APPLICATION OF NEW CINGULAR,
WIRELESS PCS, LLC FOR
A CERTIFICATE OF ENVIRONMENTAL
COMPATIBILITY AND PUBLIC NEED FOR
THE CONSTRUCTION, MAINTENANCE AND
OPERATION OF A TELECOMMUNICATIONS
FACILITY AT 95 BALANCE ROADC ROAD
HARTLAND, CONNECTICUT

DOCKET NO. 408

PRE-FILED TESTIMONY OF SCOTT EISENLOHR,
ZONING ENFORCEMENT OFFICER
THE TOWN OF HARTLAND

Deficiency between the Application for the Proposed Wireless Communications Tower at 95 Balance Rock Road, East Hartland CT and The Town of Hartland Planning and Zoning Regulations

Exhibit 2: Map of delineated wetlands and compound locations. It does not appear that a $\frac{3}{4}$ acre of continuous non-wetland acre is achieved in the area where the compound is proposed to be located.

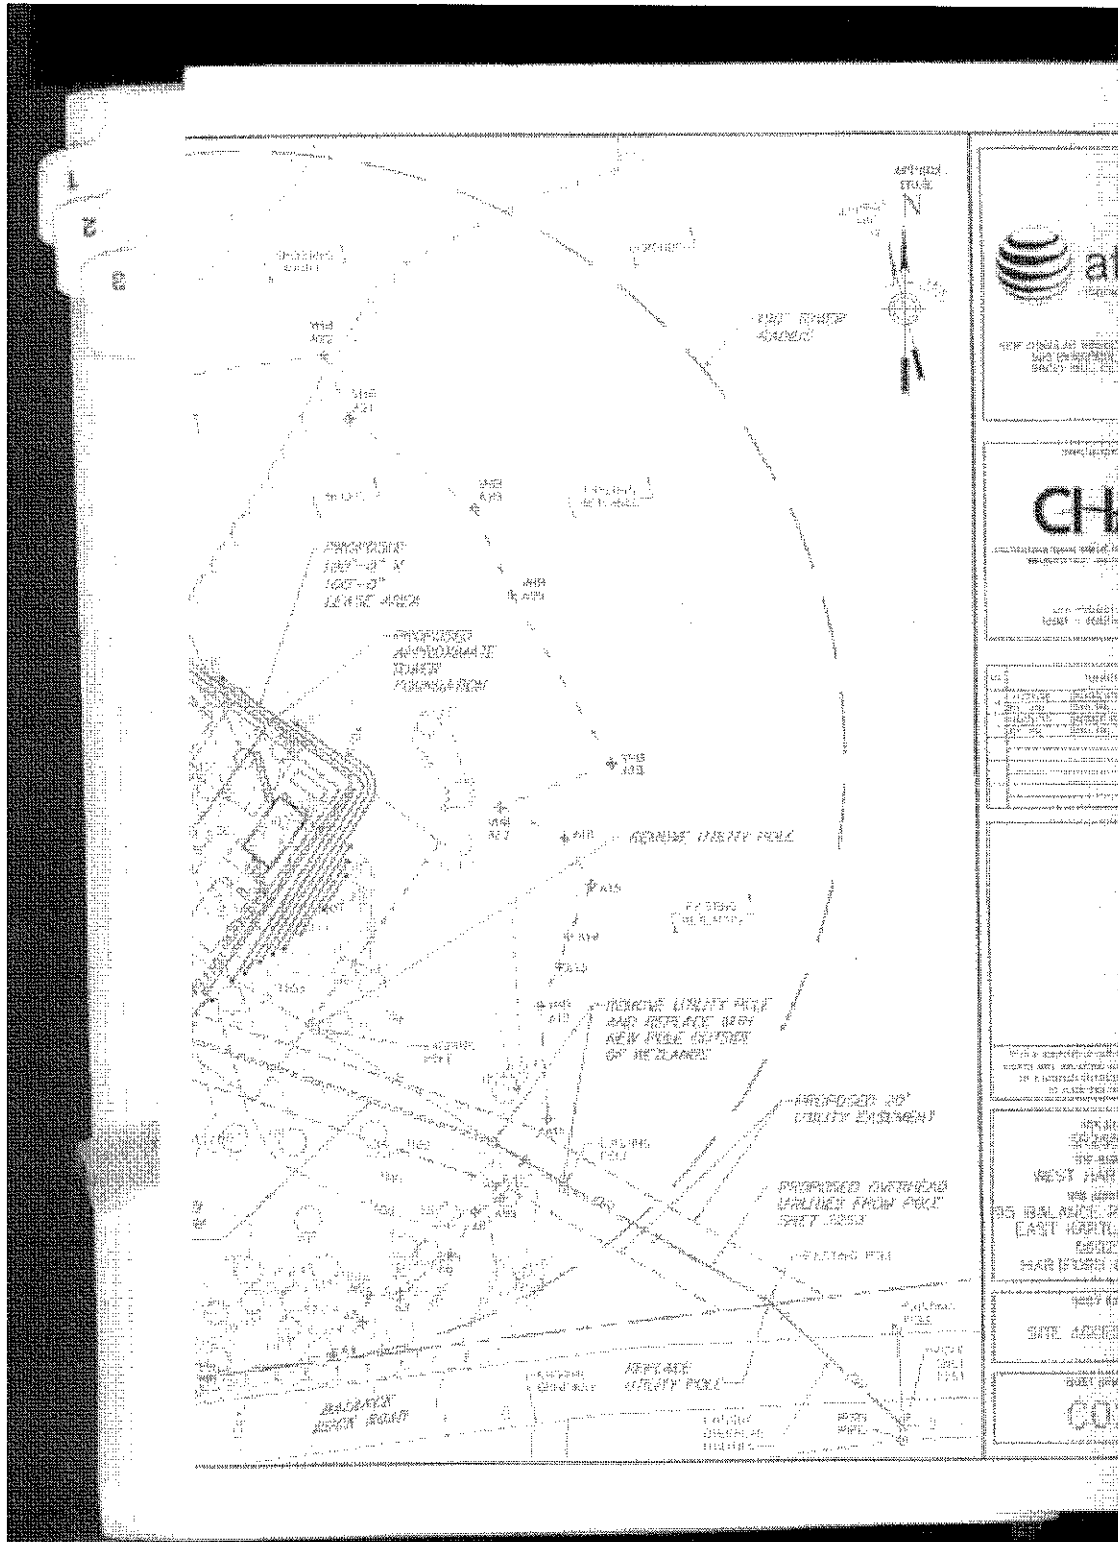
Objection: The proposed location for the wireless communication tower does not appear to contain a minimum contiguous non-wetland area of at least ¾ of an acre. **Exhibit 2** is a copy of map of proposed compound locations showing delineated wetlands.

Exhibit 3: Portion of application showing that the Applicant simply noted that repeaters were not feasible.

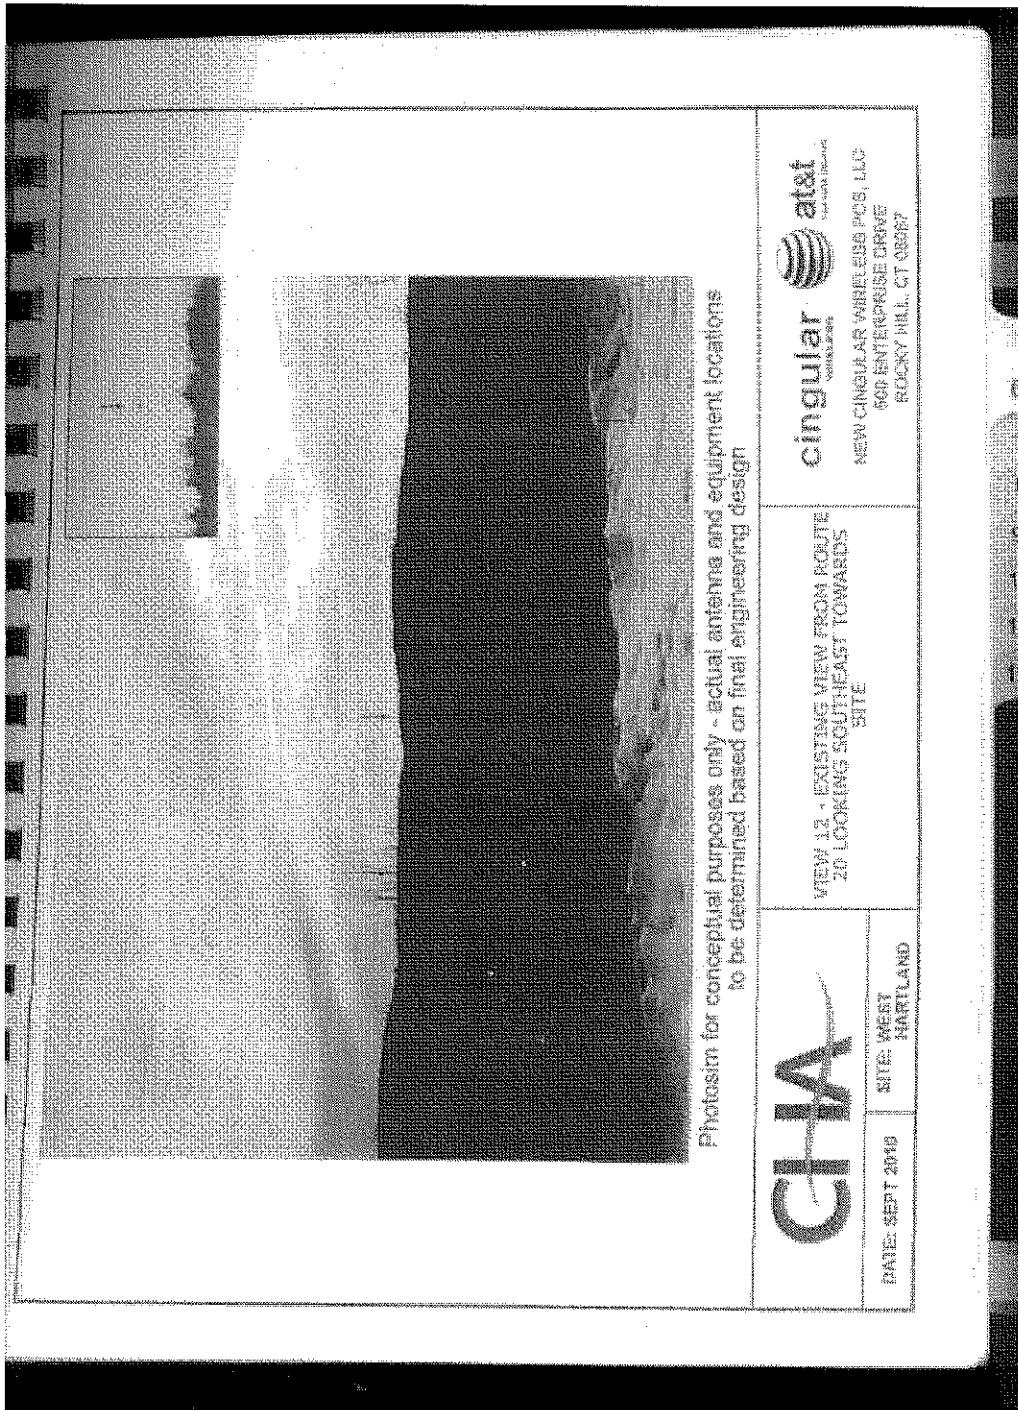
Objection: Applicant did not demonstrate with written documentation why repeaters are not a feasible alternative. Applicant merely noted in the Application that repeaters are not feasible but did not provide any supporting documentation or analysis. See **Exhibit 3**.

Exhibit 9: Wetlands delineation map of the proposed location for the wireless communication tower.

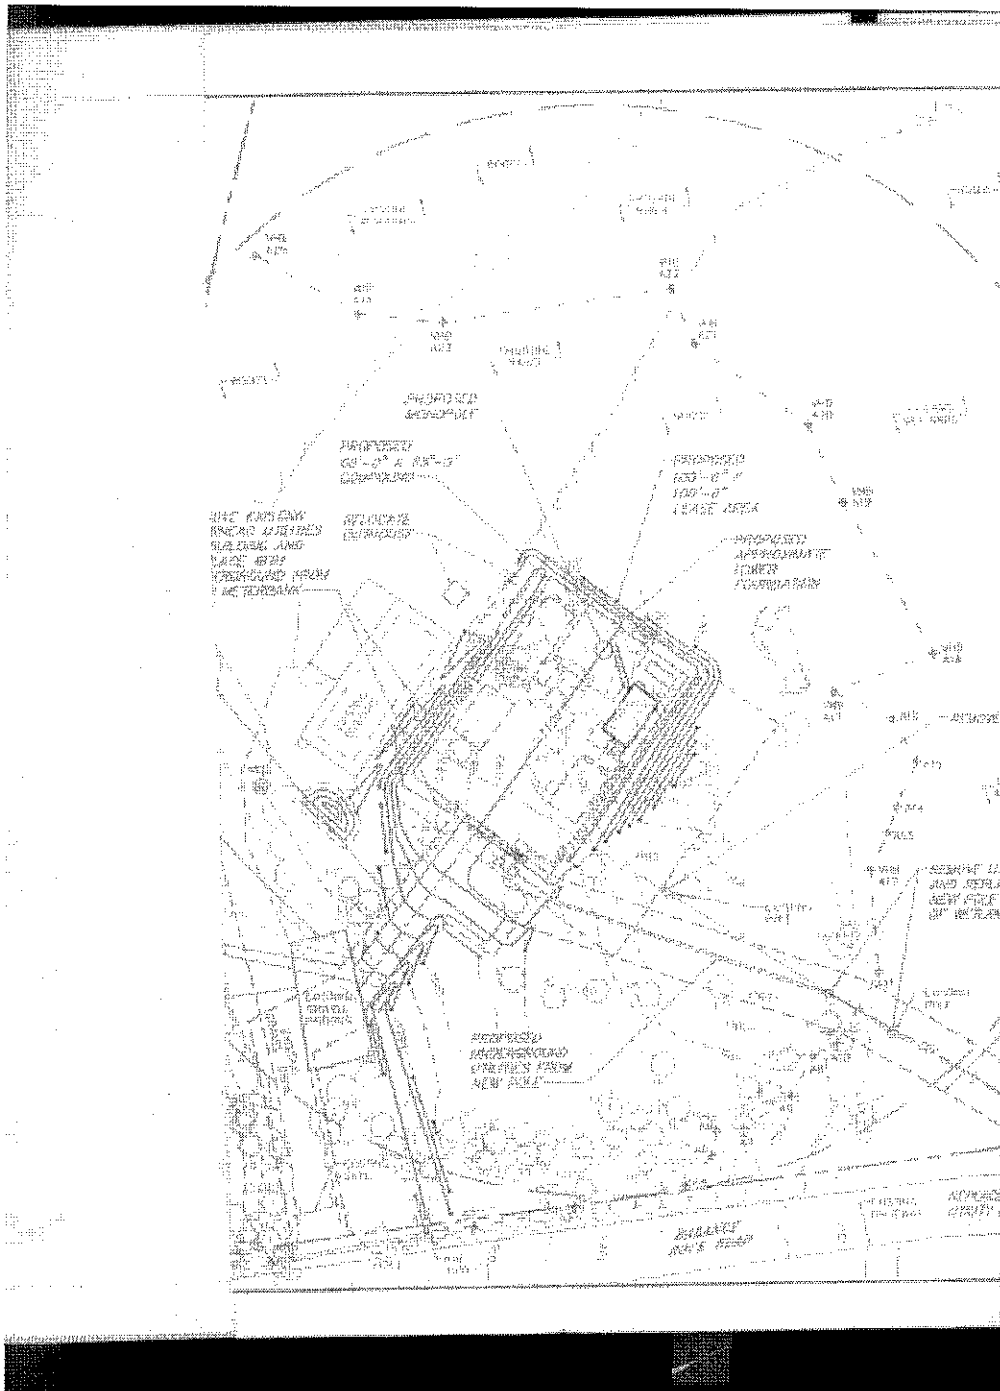
The location in which the proposed wireless communication tower is to be built is within a wetland regulated area. Point A17 on **Exhibit 9** is not located outside the 50 foot buffer required by current regulation.

In addition, points A1-A11 on **Exhibit 9** delineate an intermittent stream and thus, wetland regulations state that construction must be outside a 100 foot buffer, which is not the case. These points are located within the 100 foot buffer.

Between the existing building and the proposed wireless communication structure on **Exhibit 9** there is a drainage conduit, which appears to be an intermittent stream by definition, thereby falling within the 100 foot buffer requirement, which is not met.

FIGURE 1

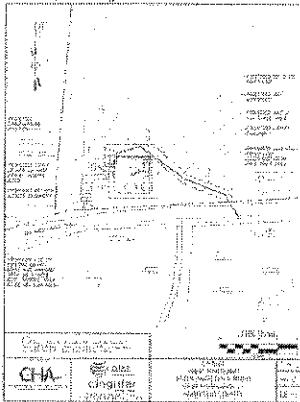
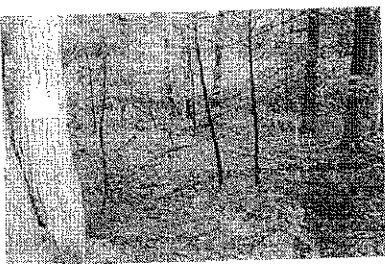
B. Saw-Whet Owl Study performed on March 23 and 26, 2010. Survey and pictures of habitat show that study was completed for the original proposed location and has not been done for the new location 110 feet farther into the property.
